TRANSMISSION REMOVAL & INSTALLATION - M/T Article Text

1984 Mazda RX7

TECHNICAL SERVICE BULLETIN

Fig. 1: 2nd Gear Synchronizer Ring and Assembly

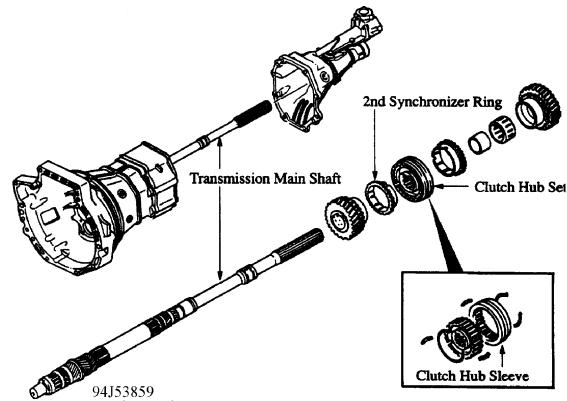
Hard shifting into second gear before the vehicle has had sufficient time to warm up may be caused by insufficient clearance between 2nd gear synchronizer ring and the 1-2 clutch hub. Design changes have been made to the 2nd gear synchronizer ring and clutch hub sleeve to correct this problem since April 1, 1991 .

If you experience hard shifting into 2nd gear after a cold start with an RX-7 (non-turbo) or Miata produced prior to April 1, 1991, replace the 2nd gear synchronizer ring and 1-2 clutch sleeve (or 1-2 clutch hub set) with redesigned ones. Refer to the appropriate service information for installation procedures.

Part Number				Description	Qty	Interchange -ability		
	New Old					3.321107			
M502	17	265C	M502	17	265B	2nd	Synchronizer Ring	1	New-Old
M503	17	262A	M503	17	262	1-2	Clutch Hub Sleeve	1 1	New-Old
M505	17	260B	M505	17	260A	1-2	Clutch Hub Set	1	New-Old

Fig. 1: Modified Main Shaft & Roller Bearing

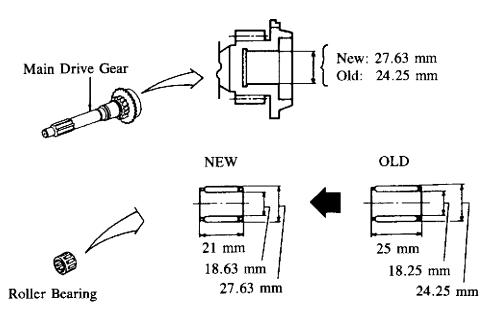
1. The roller bearing has been enlarged and the recess in the main drive gear has been enlarged to accept the new roller bearing. See Fig. 1.

Fig. 2: New Main Shaft Retaining Method

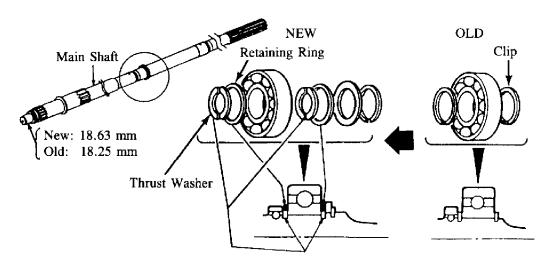
2. The method of retaining the bearing on the main shaft has been changed from clips to thrust washers with retaining rings. See Figure 2.

Fig. 1: Counter Shaft Gear & Lockup

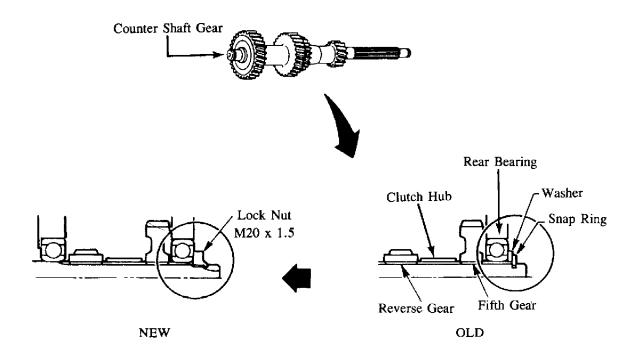
In order to retain the rear bearing on the counter shaft gear more securely, the snap ring has been replaced by a lock nut. See Fig. 1.

• Tighten the lock nut to: 94-145 ft-lb

127-196 N-m 13-20 kg-m

• Stake the lock nut as shown:

Fig. 1: New Transmission Front Bearing

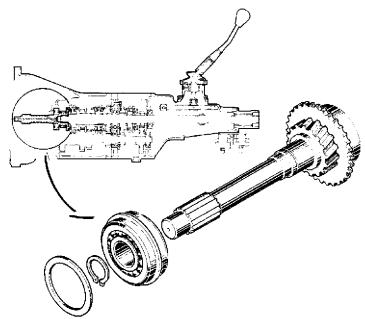
The front bearing in the transmission has been changed to a heavy duty type since the production date of January, 1984.

NEW PART NO.	OLD PART NO.	DESCRIPTION	INTERCHANGEABLE
M502 17 295	9960 63 3063	Ball Bearing	NEW = OLD
